## Roof Replacements at Antioch Water Park and Water Treatment Plant Bid No. 770-1130-22A

# ADDENDUM NO. 1 Dated November 17, 2022

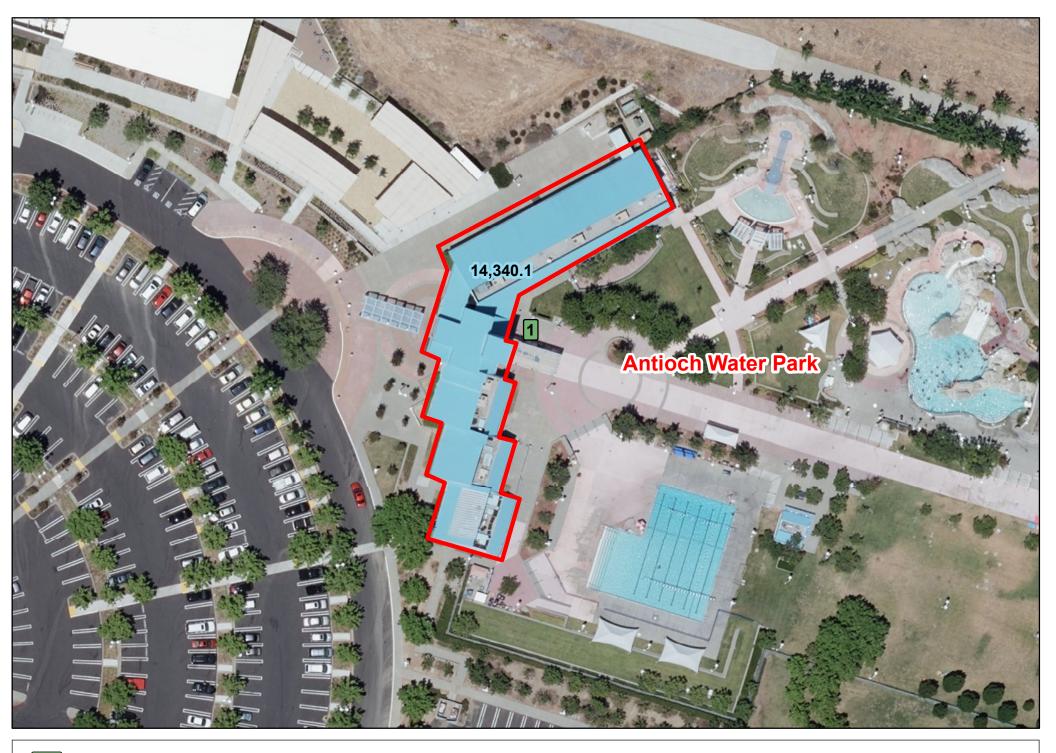
- 1. Beat blast entire surface.
- 2. Prime roof surface with GarlaBlock 2k.
- 3. Reinforce all seams with polyester reinforced butyl tape.
- 4. Install Base Coat of Liquitec at 2.5G per 100sqft.
- 5. Install Top Coat of Liquitec at 2.5G per 100sqft.
- 2. On Page 8 of 18 **replace** Antioch Water Park Map with Addendum No. 1 Map attached herein as Exhibit No. 1.
